Planning - Case Comments

Project Number: PR-2023-009368

Project Name: Farolito Senior Community

Requests: Site Plan – Administrative DFT

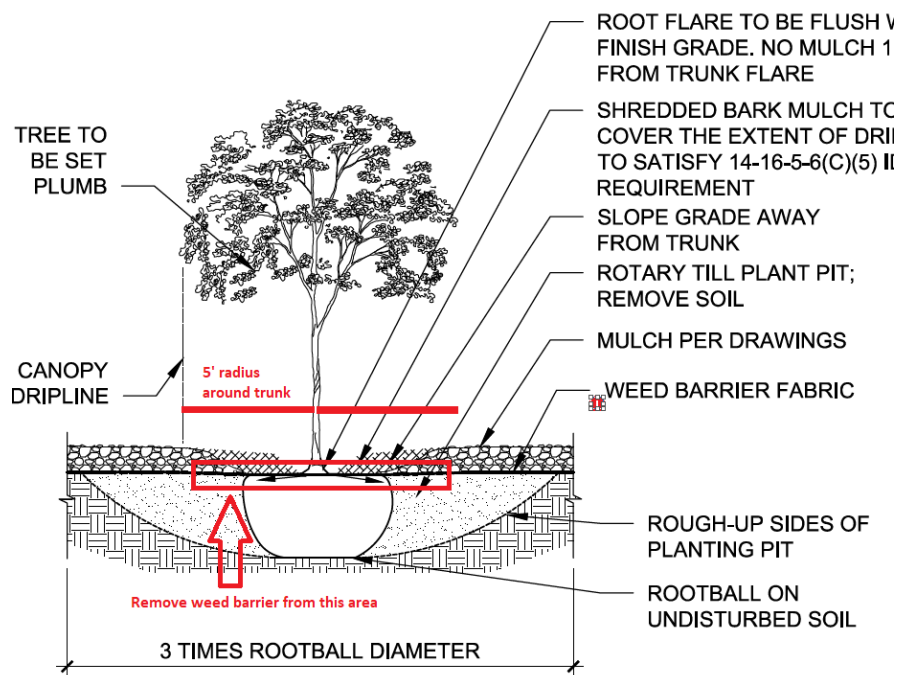
- Per 5-6(C)(5)(e) Organic mulch is required as ground cover under trees within a 5-foot radius around the tree trunk, but not directly against the trunk. In these areas, weed barrier fabric is prohibited. Please correct tree planting detail to show a 5-foot radius bark mulch around the tree trunk. Please remove the weed barrier extension from this 5-foot radius area. Please see below:
